Product Change Notice: Electromechanical EWW-Yx Series Center Spaced Rotary Potentiometers

PCN.PG13.2.13.2021

2.13.2021

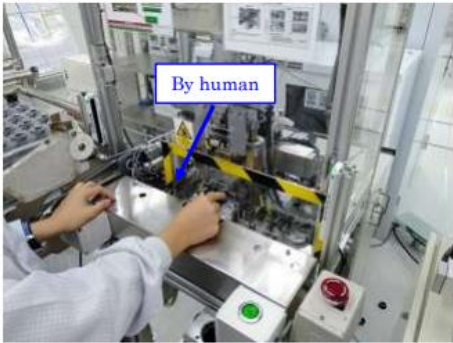
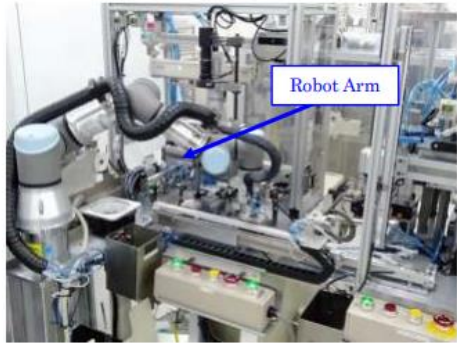
Current Condition (Pressing Punch)	New Condition (Laser Marking Unit)
  <p data-bbox="430 903 714 934">Contents no change</p>	  <p data-bbox="1023 903 1307 934">Contents no change</p>
